PORSCHE

Current positioning of the rear fog lamp

Future position of the rear foglamp leads to improved stop lamps

spoiler fully opened

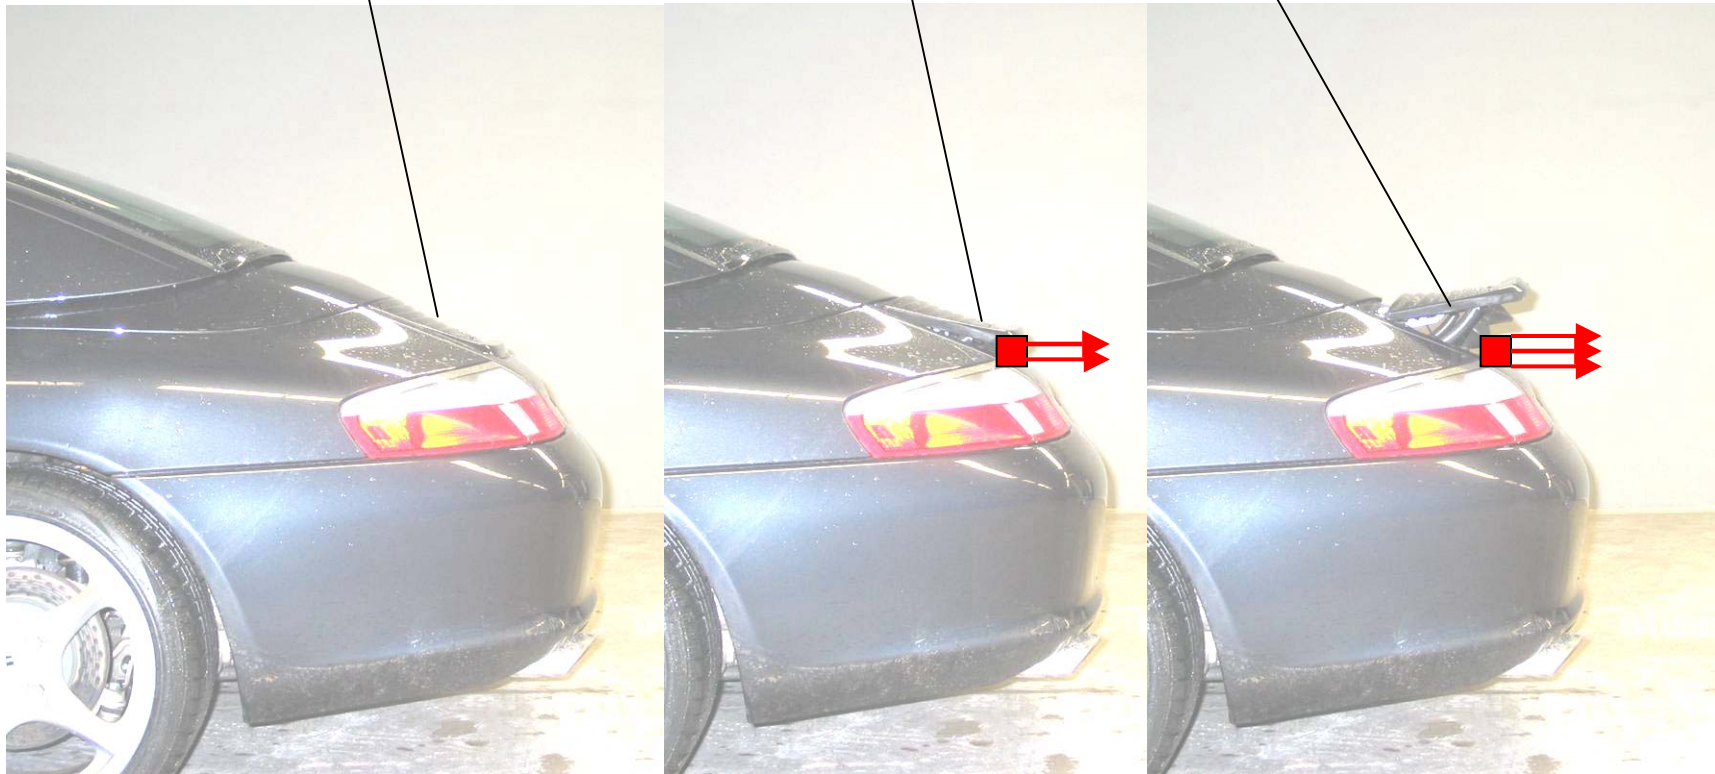
spoiler closed
rear fog lamp
concealed

spoiler just opening
rear fog lamp
becomes visible
when activated
